Summary of false claims made by Cornell University in its variance request (No. 2016-0269)

Prepared by Jonathan Ochshorn for the June 15, 2017 meeting of the New York State DCEA Syracuse Regional Board of Review.

2. The second floor area of Rand Hall is 9,300 sq.ft.	<p>The second floor area of the combined building is about 41,600 sq.ft.</p>  <p>Figure 1. Second-floor areas of Rand-Milstein-Sibley Hall (dotted lines represent noncompliant 1-hour fire barriers)</p>

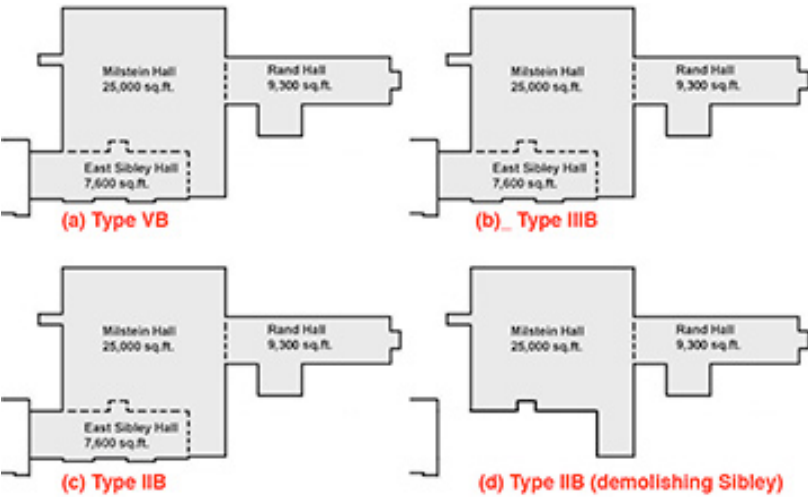
3. The actual second floor area (9,300 sq.ft.) is smaller than the allowable area for IIB construction (33,915 sq.ft.)	The actual second floor area (about 41,900 sq.ft.) is much greater than the allowable area for IIB construction (33,915 sq.ft.). But it's even worse when the <i>actual</i> VB construction type is considered: in that case the allowable area is only 21,420 sq.ft. (Calculations include frontage factor of 0.57.) Rand and Milstein Halls all by themselves, without including Sibley Hall, exceed the allowable area, <i>even assuming Type IIB construction</i> .
